**Planning Commission
Council Chambers
July 19, 2022 – 6:00 p.m.
233 South Main Street, Monroe, Ohio**

TO: Members of the Monroe Planning Commission
FROM: Kameryn Jones
Assistant Development Director

DATE: July 19, 2022
RE: Information Packet for July 19, 2022 Planning Commission Meeting at 6:00 p.m.

III. Case No. 2022-7-8. Consideration of Site Plan Application for a Medical Marijuana Dispensary on Clarence F Warner Drive

NORTH ELEVATION

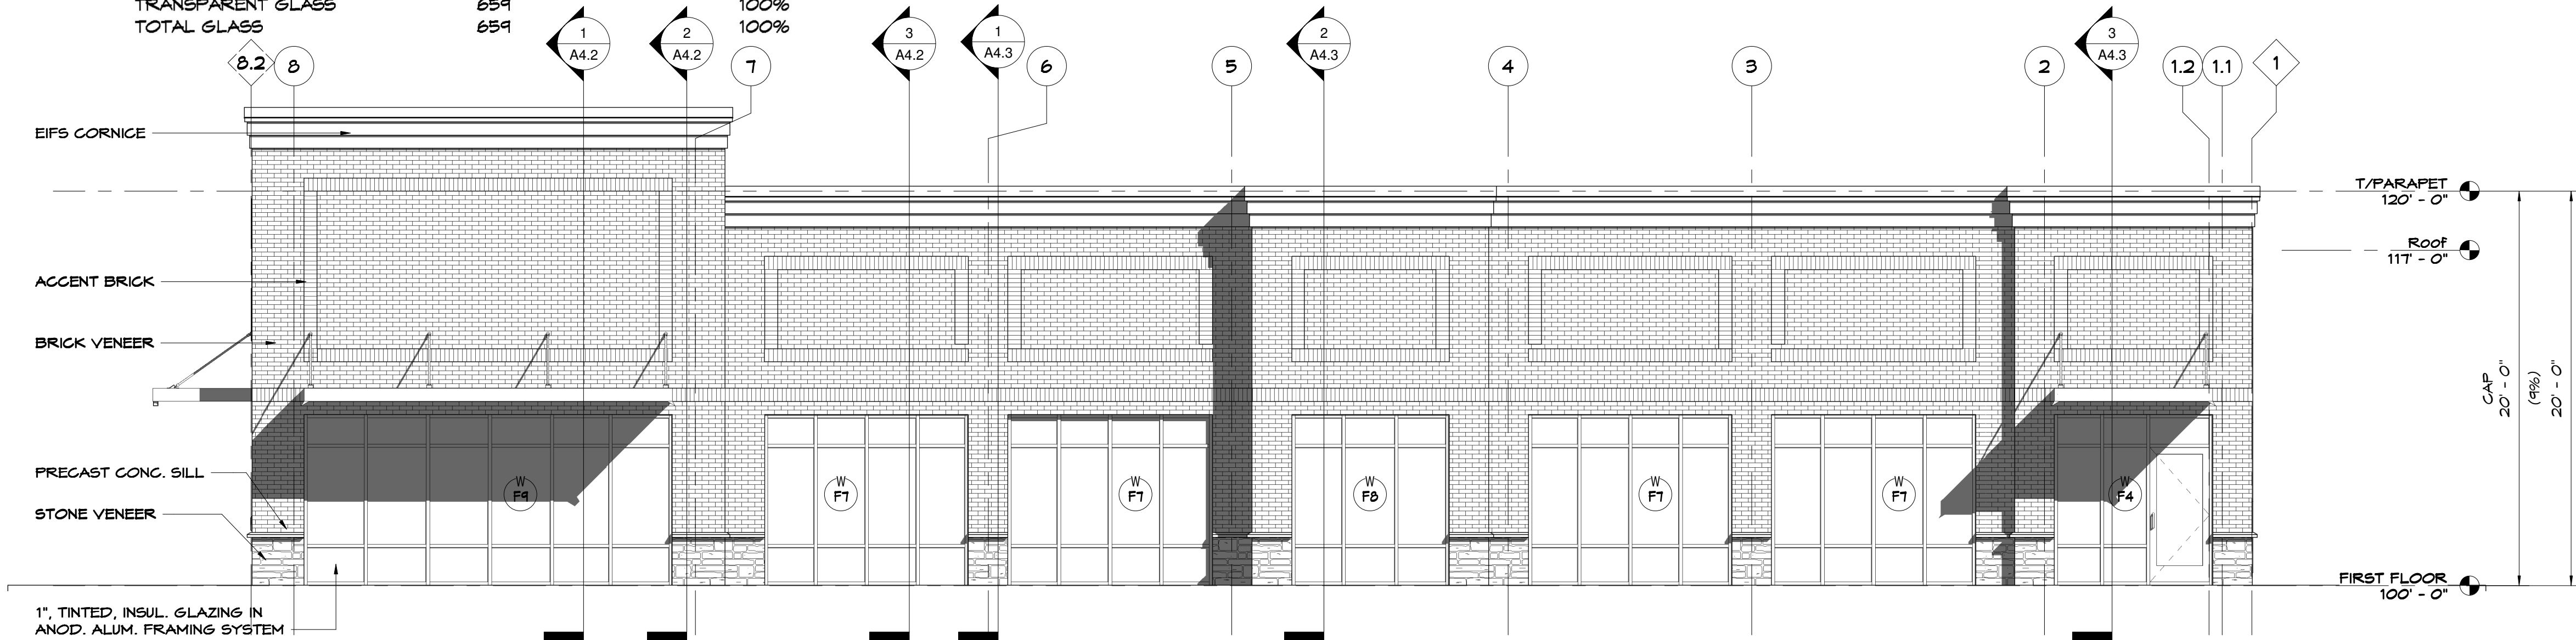
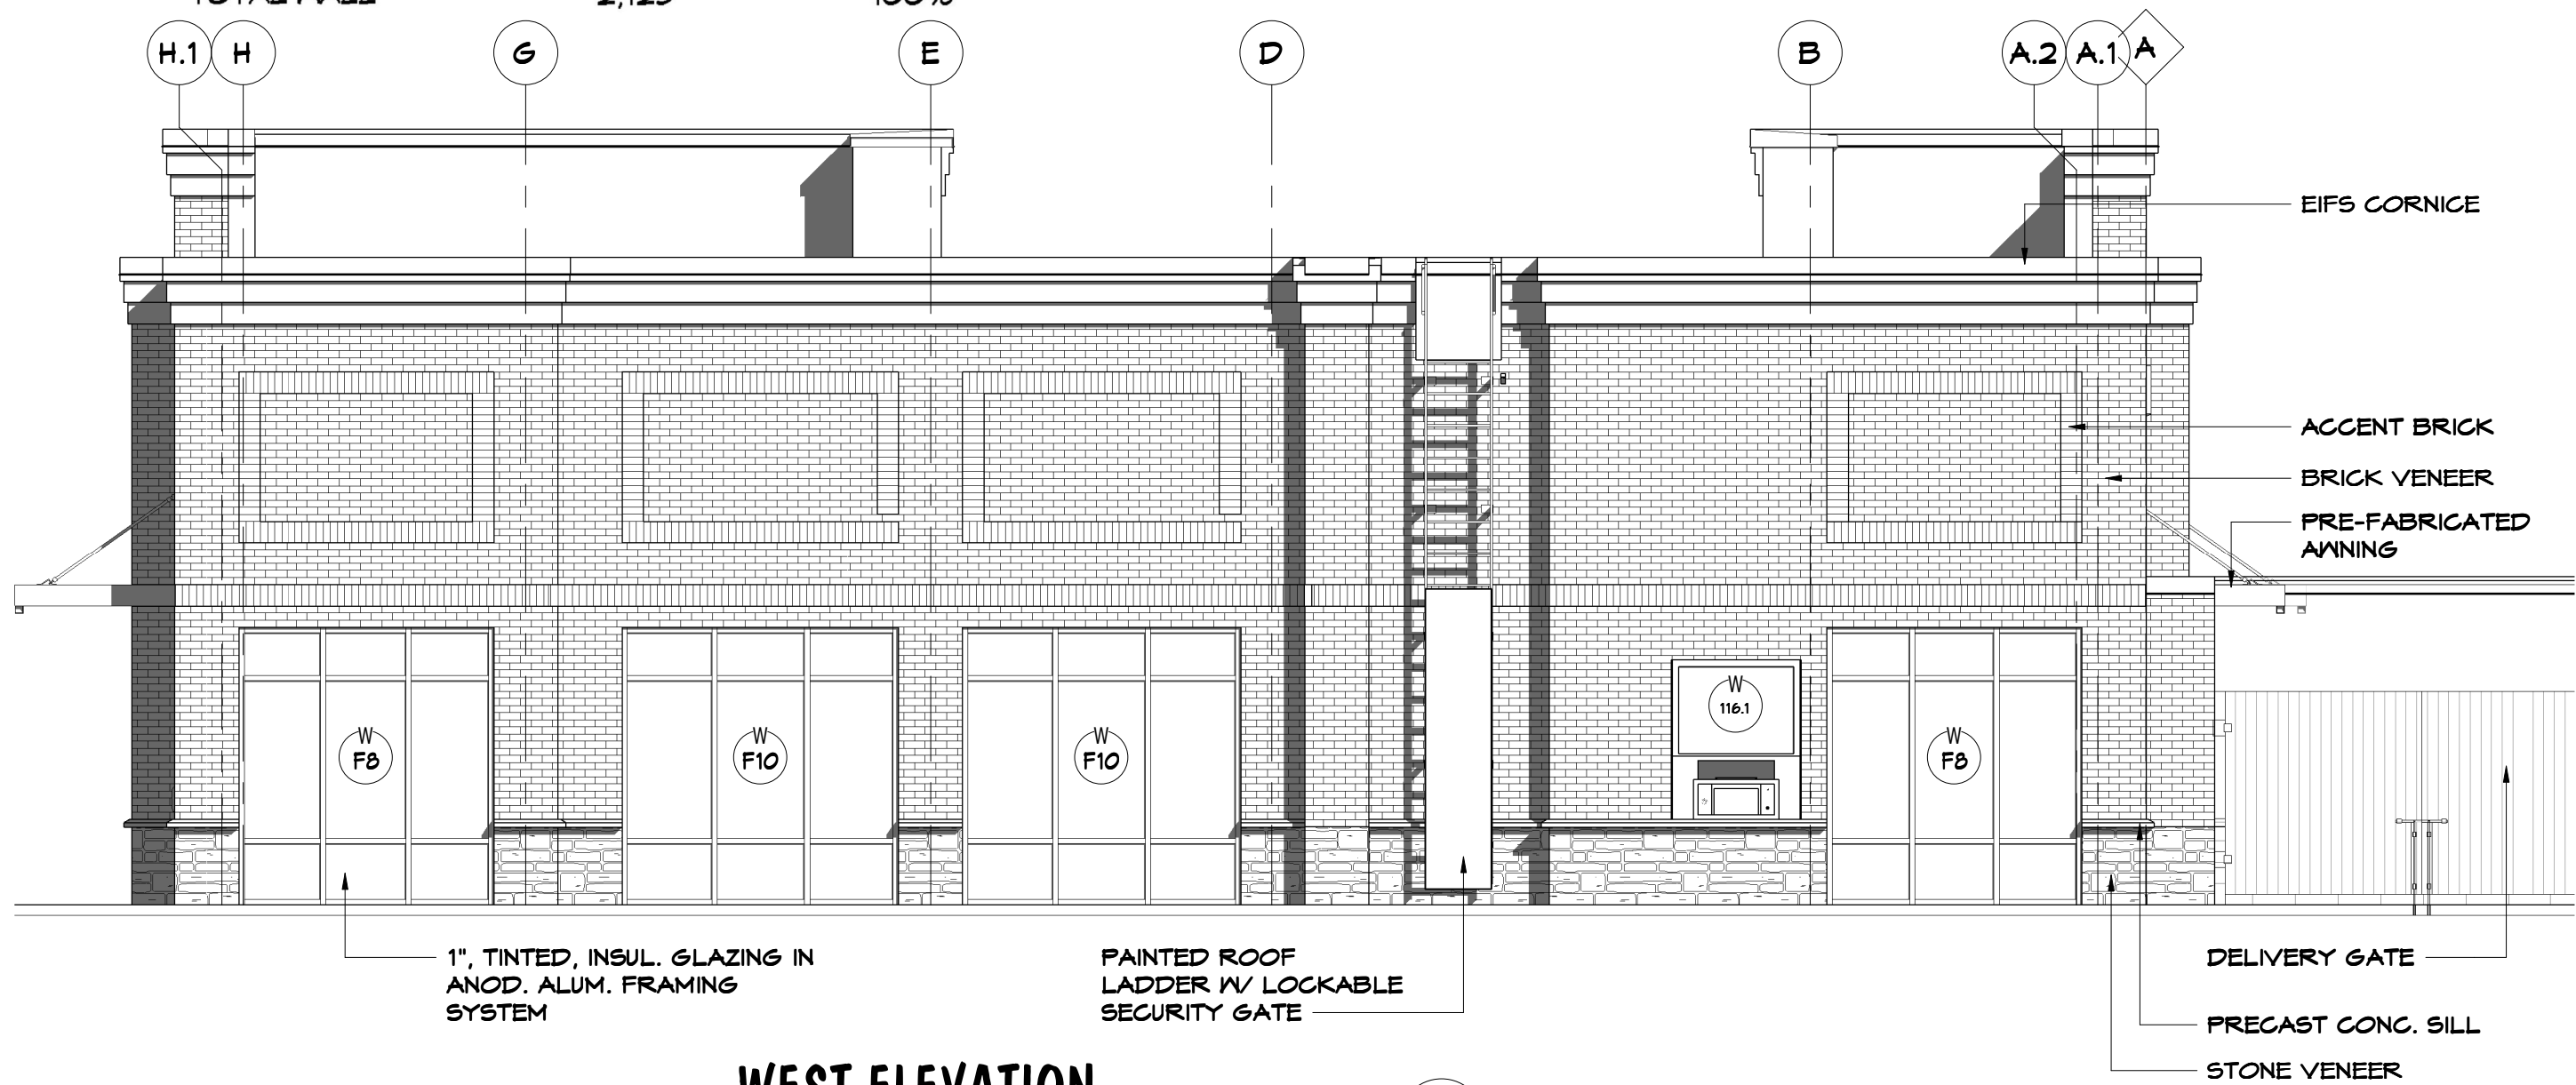
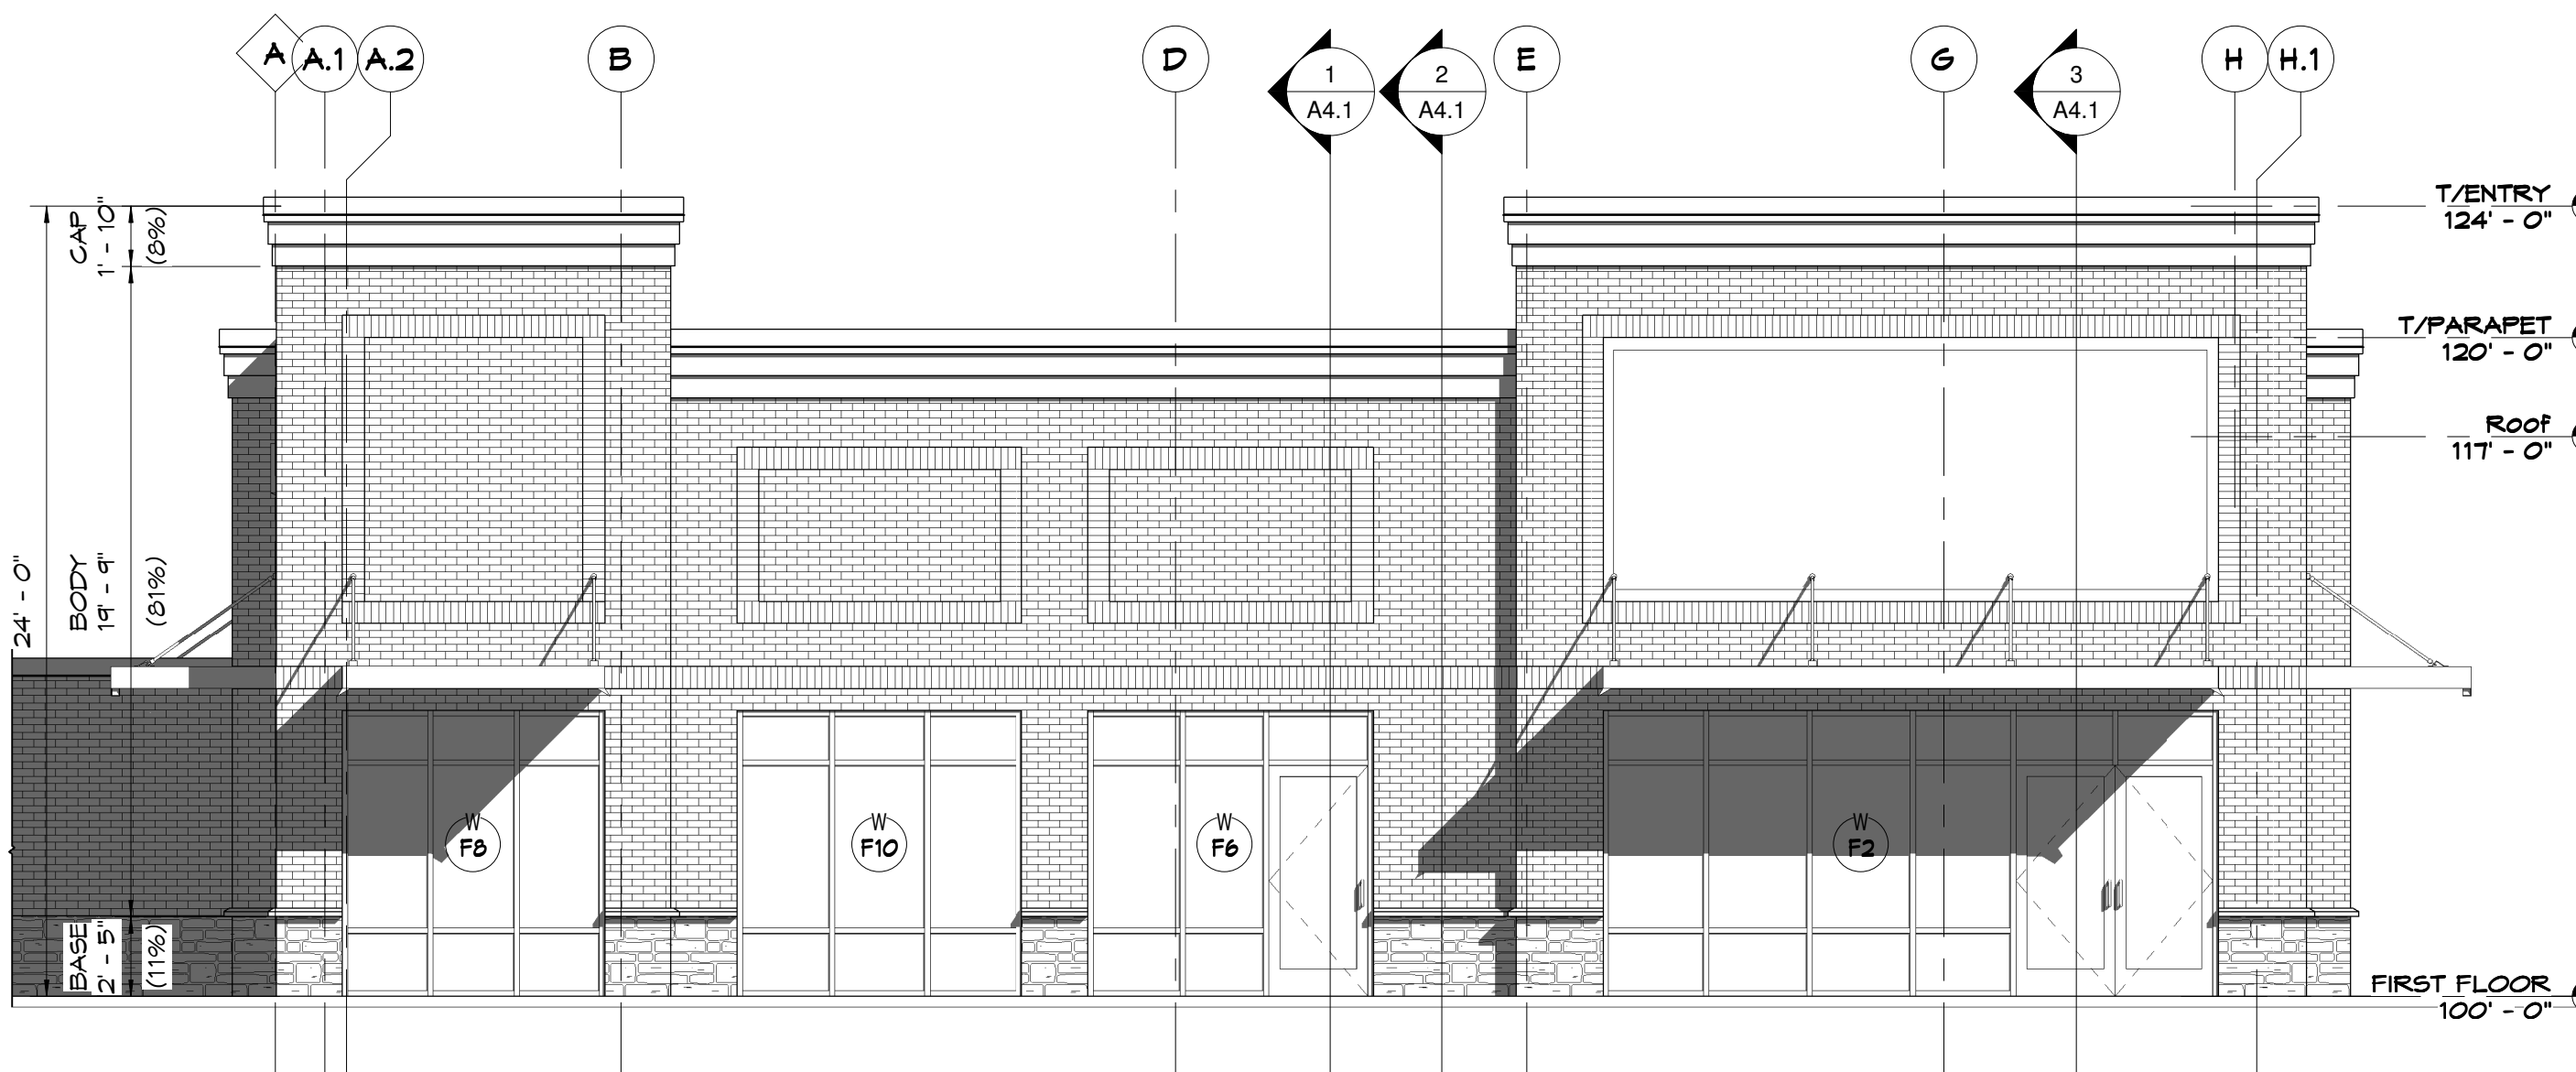
- **Architectural:**
 - Base-body-cap appears to be met across the building with exception of areas where the windows go to the floor. Typically, Planning Commission has approved this option.

C-3

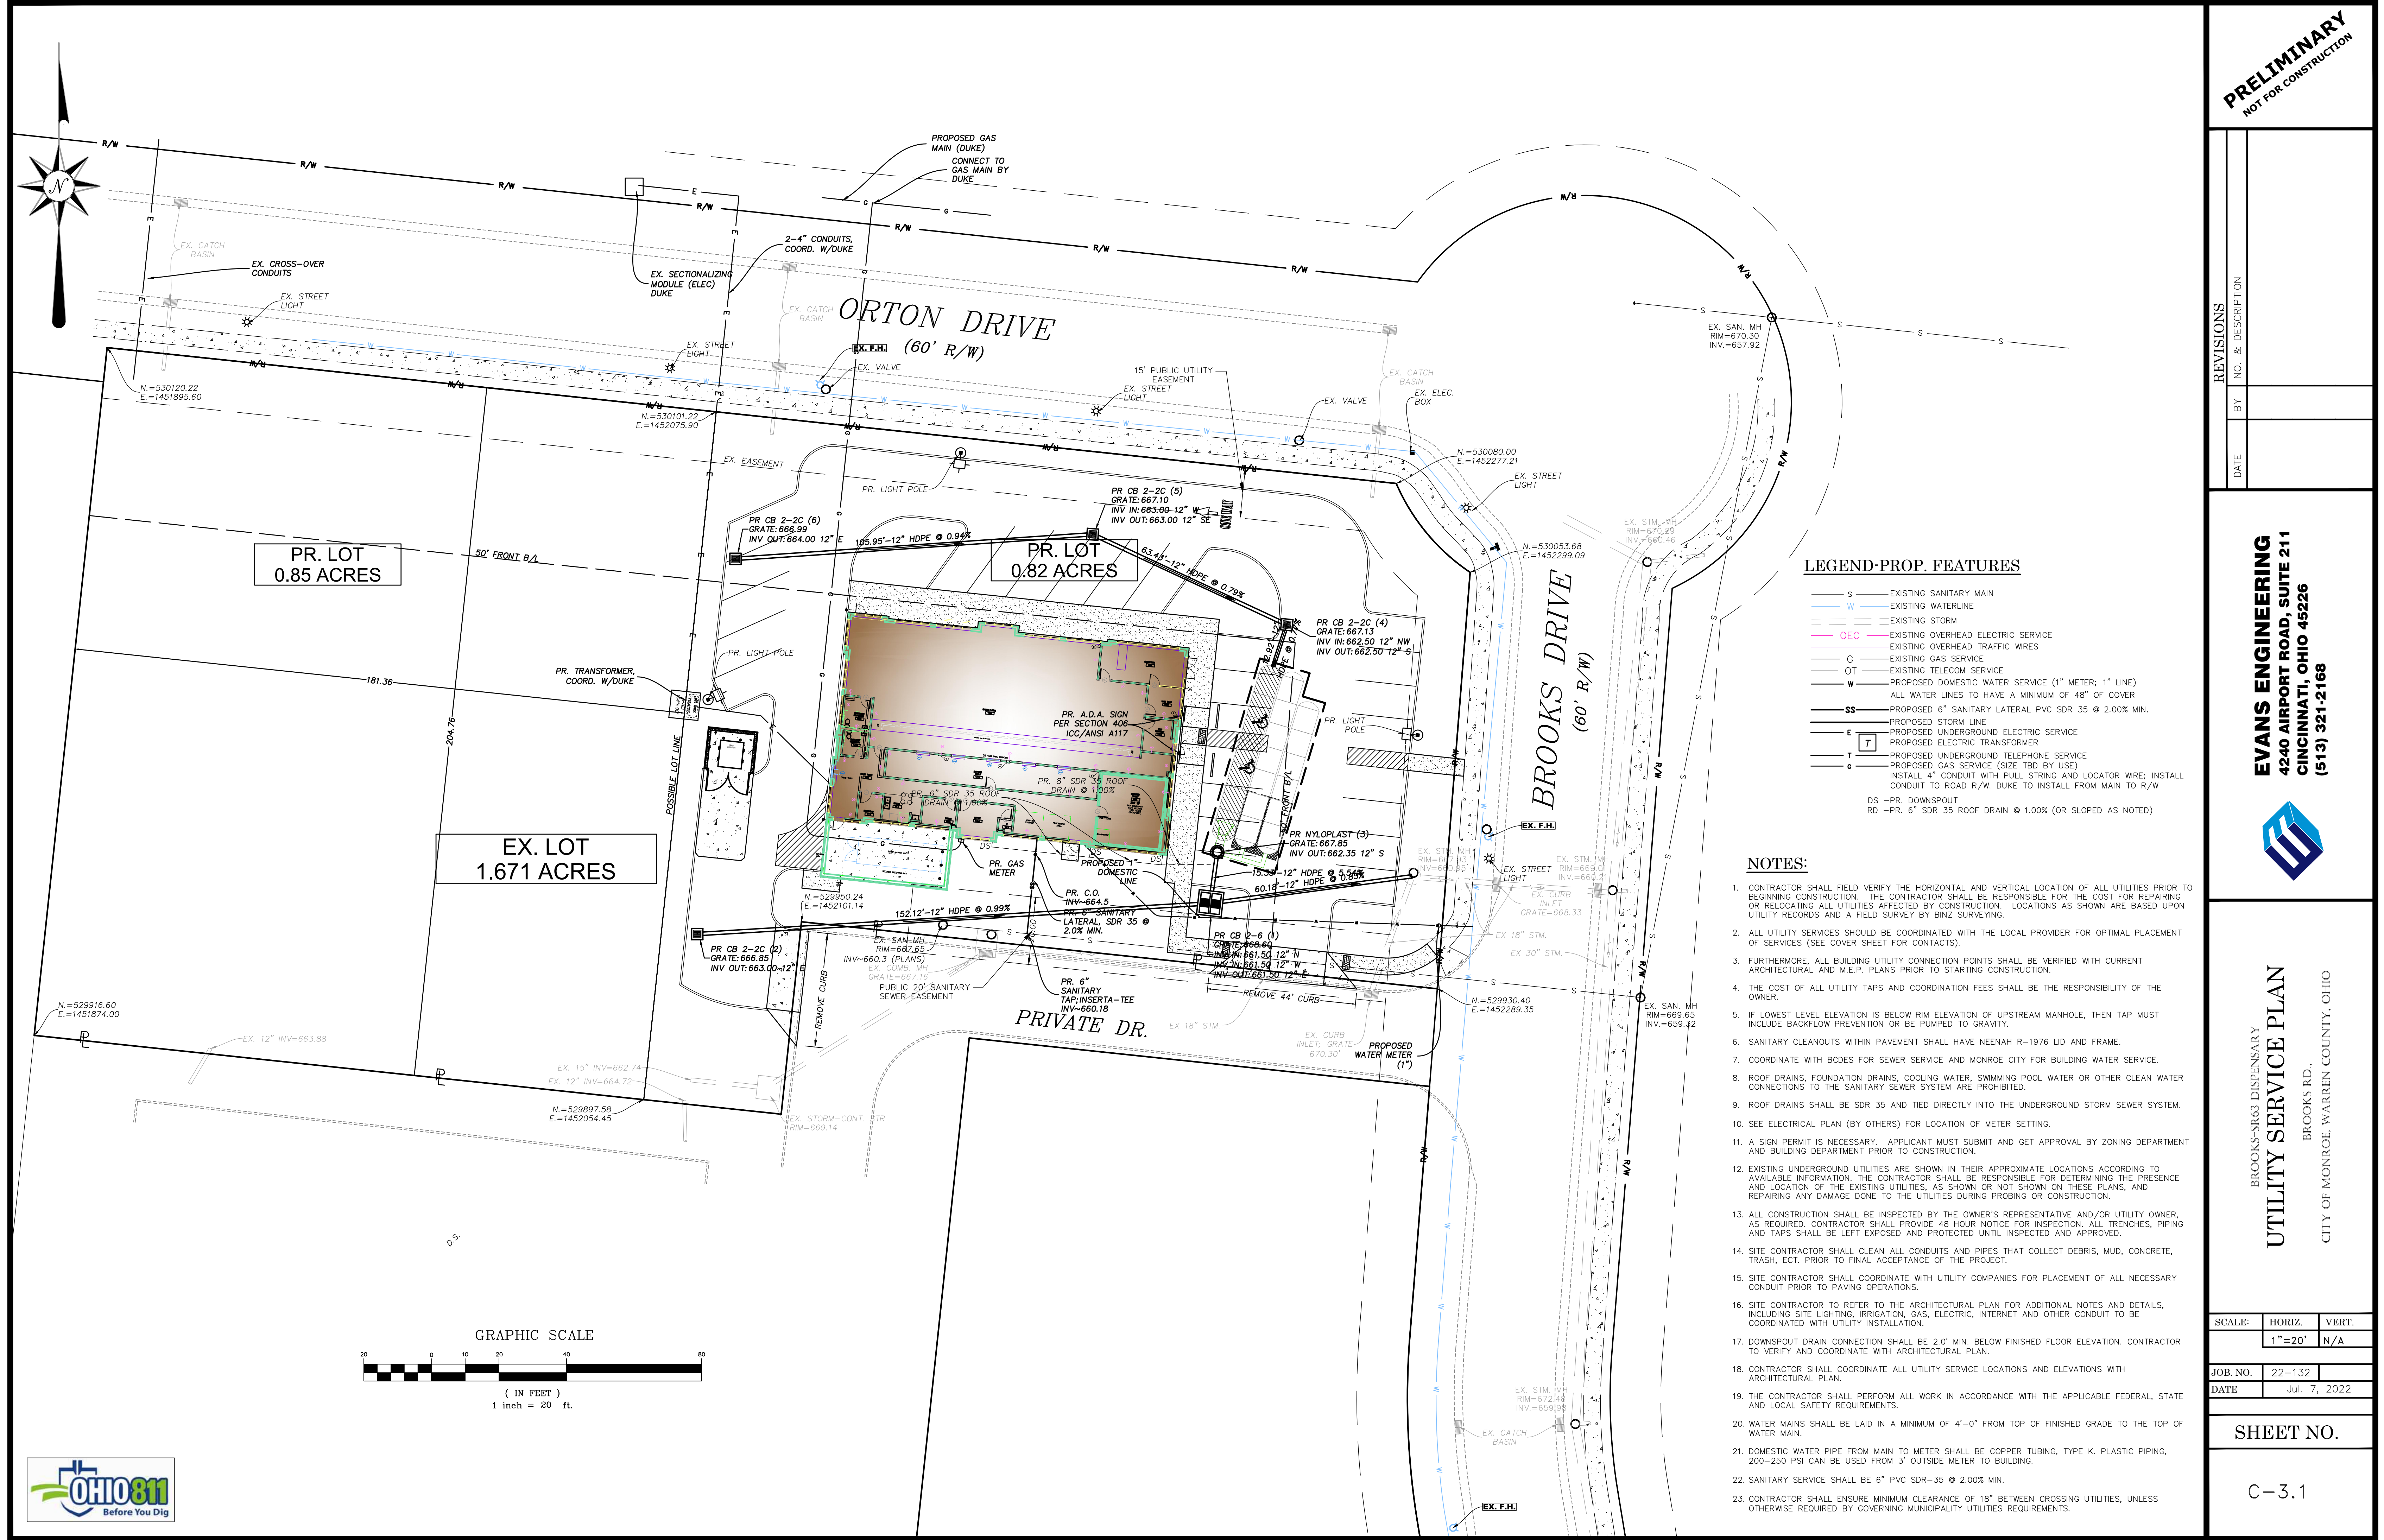
- **General:**
 - The lot line as shown would create a landlocked parcel to the east, where the recently approved CCC North building will be located.
 - To avoid creation of a landlocked parcel, which is prohibited by Code, the applicant must either create a panhandle lot to provide frontage to the CCC north parcel or dedicate (turn from private to public road) this portion of Clarence F. Warner Drive.

- Dimensions have been added to Sheet C-3 to show 6ft area.
- Landscaping is shown on the east side of the building.
- Tree spacing along right-of-way has been fixed.
 - o 1 Additional tree has been added.
- Understood.
 - o A substantial amount of landscaping is proposed, it's covered now.
- Understood.
- Understood.
